Fox Delta

FD- PM3A

PM3A PCB Error & other important points for Kit Builder:

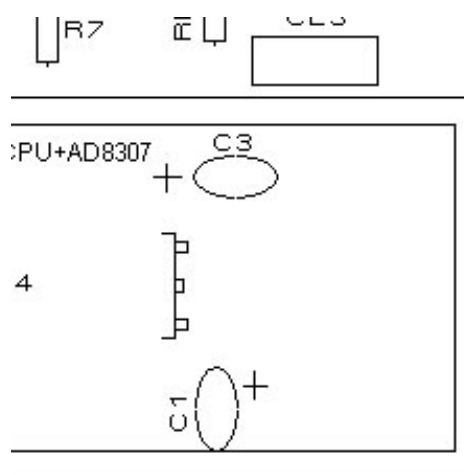
There is a silk print error at C3. Polarity mark is at wrong place.

The Wrong is here:

Correct is here:

Key Board PCB Width:

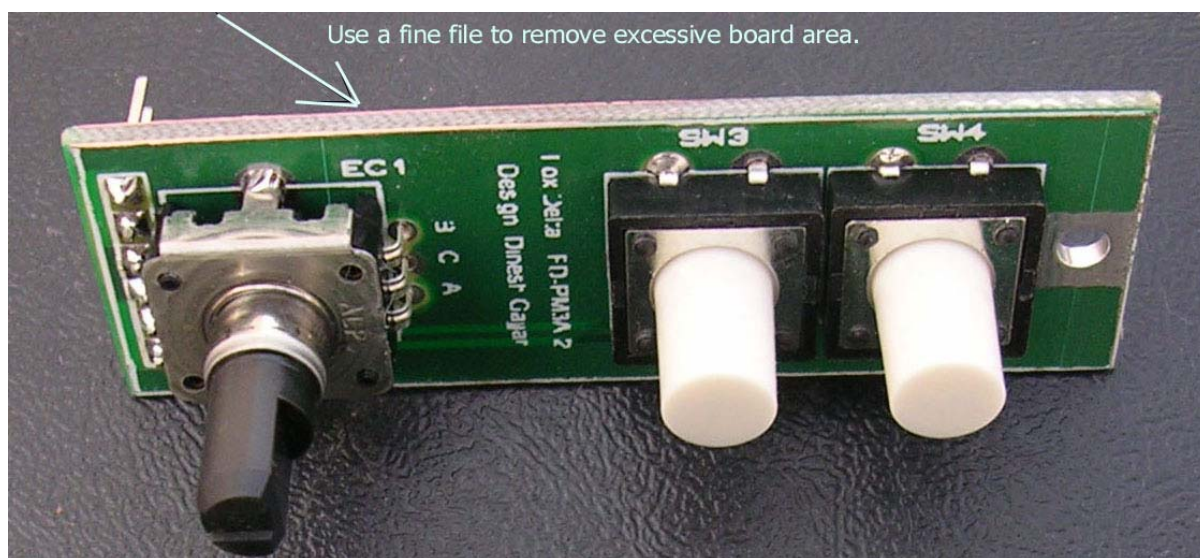
Most KB PCBs are ok. Some may be wider by a millimeter. If KB PCB is touching LCD PCB, please grind it using a fine file or sand paper.
